AGENDA

The Columbia Historic Zoning Commission will meet on Thursday, May 12th, 2022 at 4:00 p.m. in the Council Chambers on the basement level of City Hall, 700 N. Garden Street to consider the following:

CITY OF COLUMBIA TENNESSEE
 HISTORIC ZONING COMMISSION
 STAFF REPORT

PROJECT DESCRIPTION: Revision to Certificate of Appropriateness

SITE PLAN

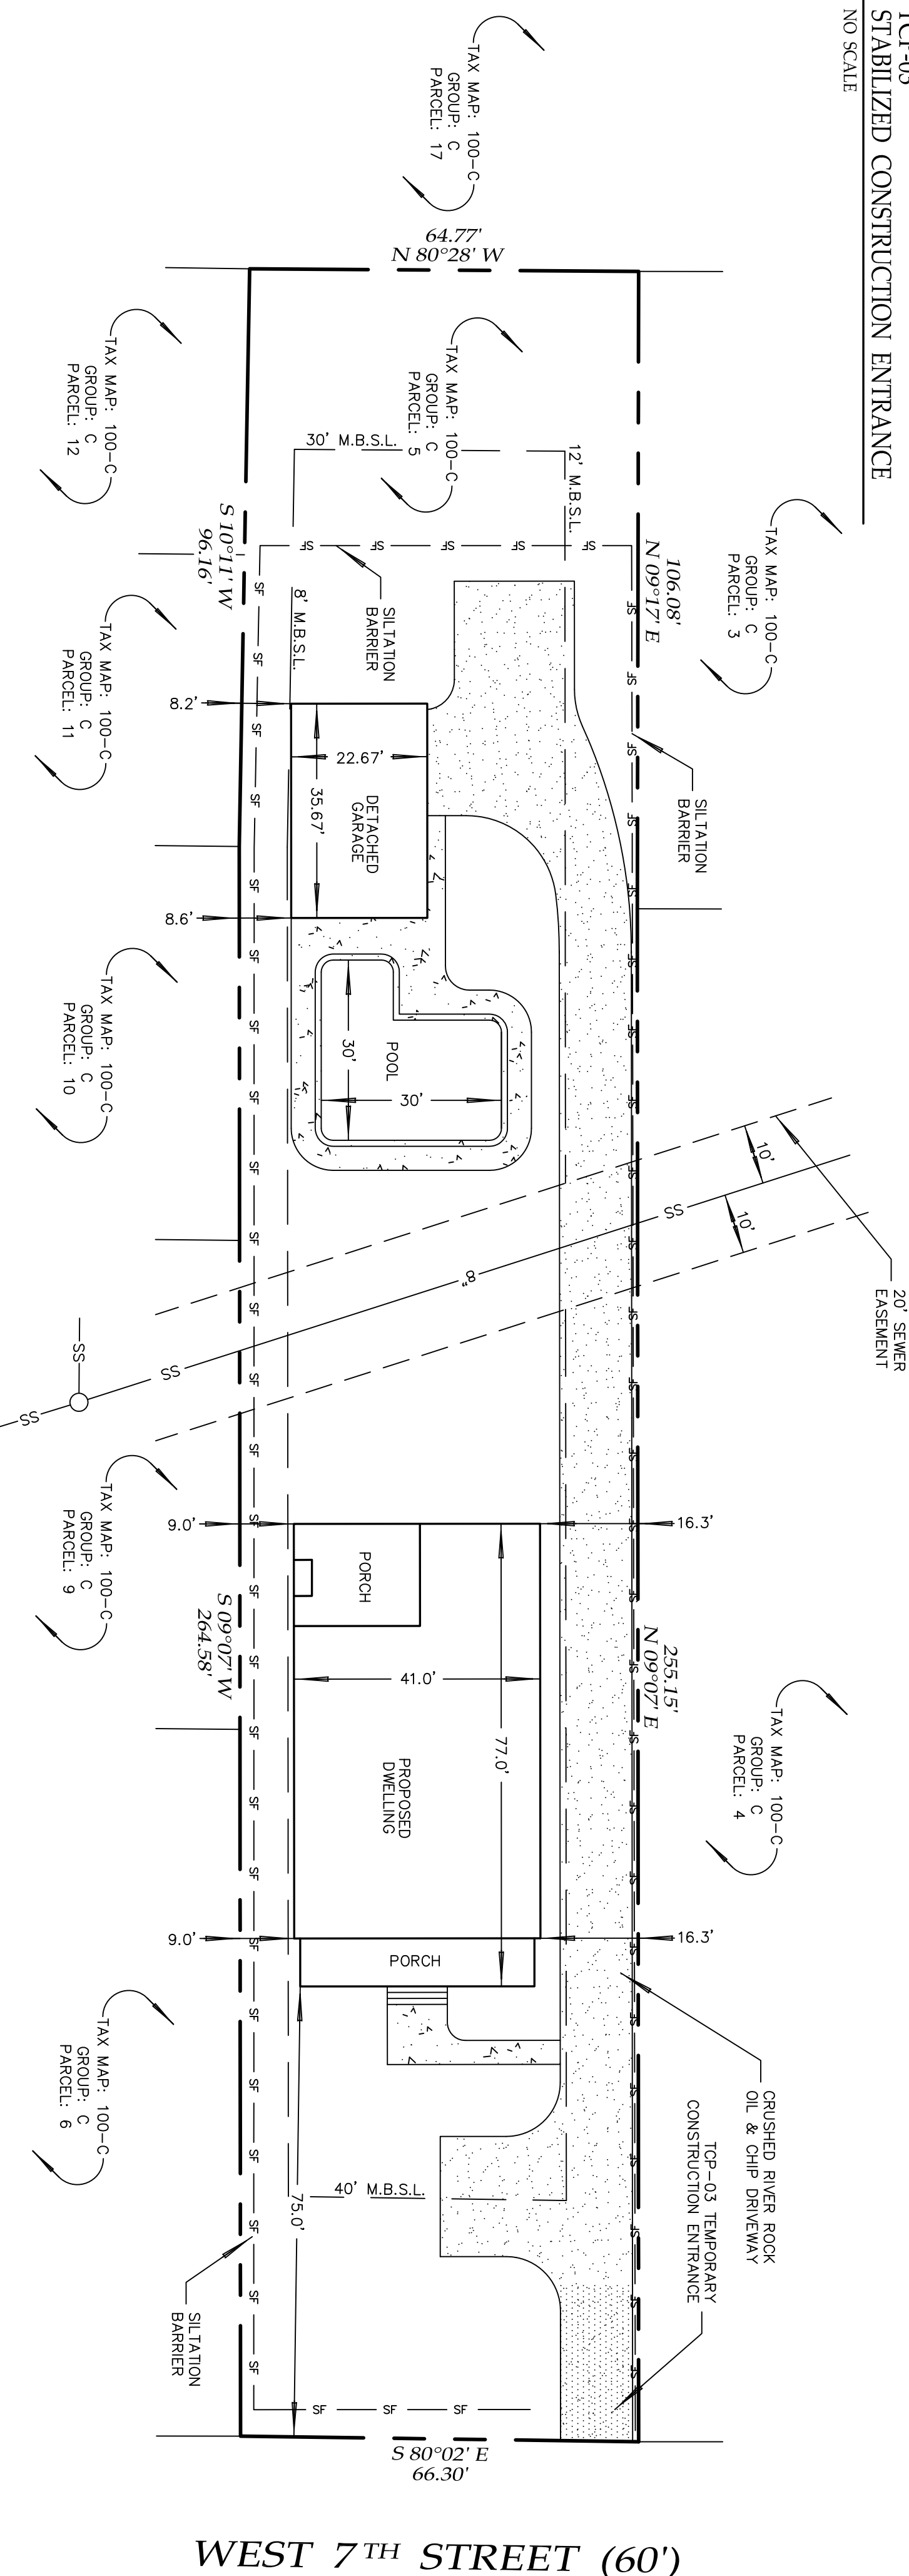
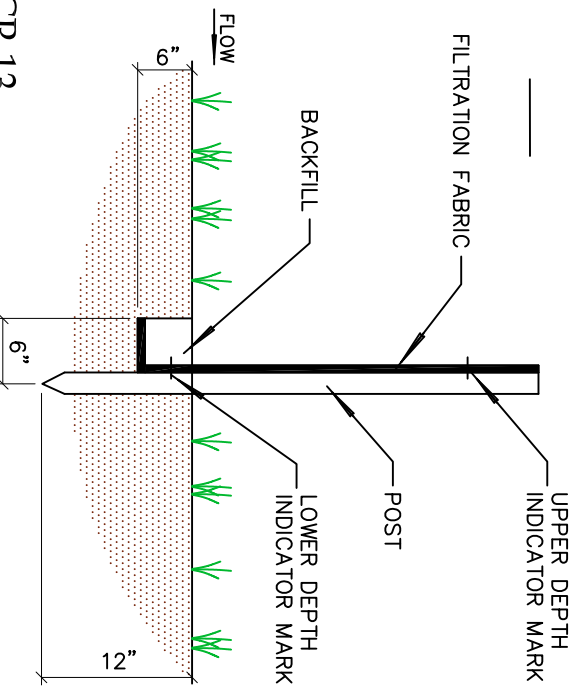
- As depicted in the applicant’s site plan, the proposed residence generally conforms to the standards of the Zoning Ordinance for an R-10 zone. The driveway should be adjusted to be at least 5 feet from the property line. Staff will perform a more detailed review at the time building permit.
- The standards for review at 3.12.4 are incorporated into the Design Guidelines.
- In the event the Commission votes to deny the request, the motion and subsequent discussion must identify the reasons for denial and recommendations for revising the proposed signage.

Sign Notes:

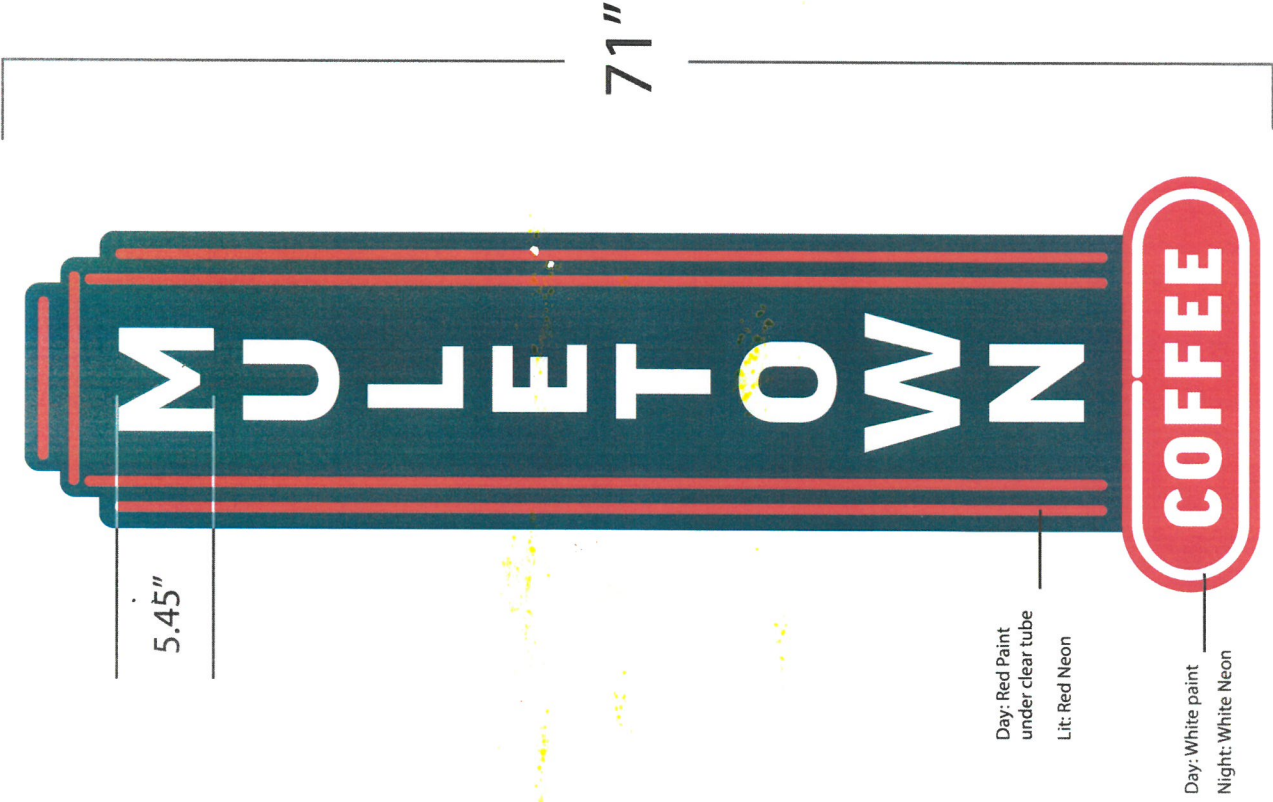
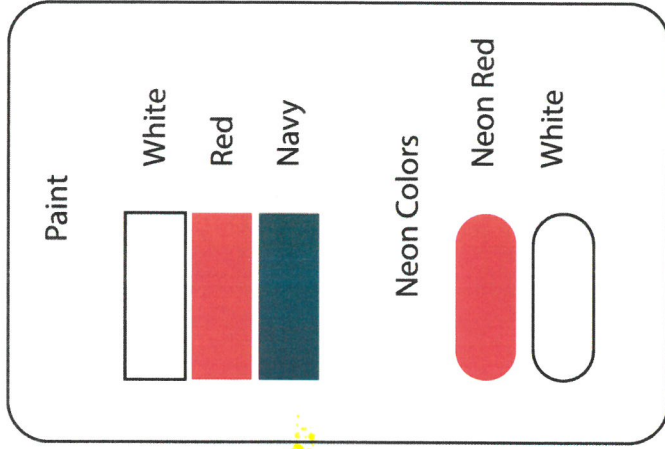
- The proposed signage will be mounted on this portion of the building and may obstruct a character-defining feature of the building. However, the building's ground floor façade has been repeatedly modified throughout its history as different businesses have utilized the storefronts. Some buildings in the District are distinguished by projecting signs. A projecting sign in keeping with the historic character of the District may compliment the character-defining elements of the building and itself become a distinguishing feature over time.
